Access Compliance Report

Public Rights-of-Way

Intersection ID: 42739	Main Street: CALDWELL RIDGE PY	Cross Street: LEES CROSSING DR	Location: NW
ADA ID: F1E27A1F5042	Ramp Type: PerpDiag	Initial Pass/Fail: Fail	Overall Compliance: No
Severity Score: 12.5			
Codes/Mitigation Info/Possible Solution		Field Measurements/Component Compliance

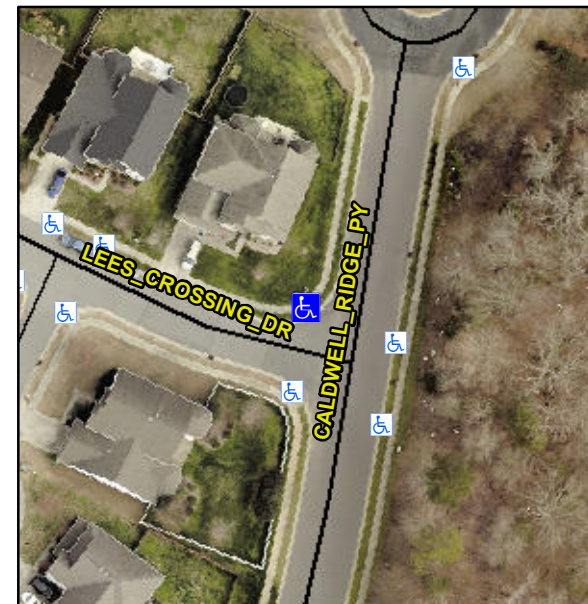
Not Found, R304.5.3

Compliance	Description	Data	Compliance	Description	Data
N/A	Ramp Length (in)	44.5	Yes	Ramp Slope (%)	5.9
Yes	Ramp Width (in)	48.0	No	Ramp XSlope (%)	6.1
N/A	Flare Type LT	N/A	N/A	Flare Type RT	N/A
N/A	Flare Slope LT (%)	N/A	N/A	Flare Slope RT (%)	N/A
N/A	Flare Traversable LT?	N/A	N/A	Flare Traversable RT?	N/A
N/A	Landing Length (in)	N/A	N/A	DWS Provided?	N/A
N/A	Landing Width (in)	N/A	N/A	DWS Contrast?	N/A
N/A	Landing Slope (%)	N/A	N/A	DWS Length (in)	N/A
N/A	Landing X Slope (%)	N/A	N/A	DWS Full Width?	N/A
N/A	Landing Curb? (Y/N)	N/A	N/A	DWS Offset (in)	N/A
N/A	Shared Landing?	N/A			
N/A	Gutter Ponding?	N/A	N/A	Gutter Slope (%)	N/A
N/A	Gutter Lip Ht (in)	N/A	N/A	Gutter X Slope (%)	N/A
N/A	Painted X Walk1?	No	N/A	Painted X Walk2?	No
	X Walk 1 Direction	To S		X Walk 2 Direction	To E
N/A	X Walk 1 Width (in)	N/A	N/A	X Walk 2 Width (in)	N/A
	X Walk 1 Slope (%)	0.1		X Walk 2 Slope (%)	6.2
	X Walk 1 X Slope (%)	5.1		X Walk 2 X Slope (%)	5.3

Remove & Replace Curb Ramp With Two New Directional Ramps or Equivalent.
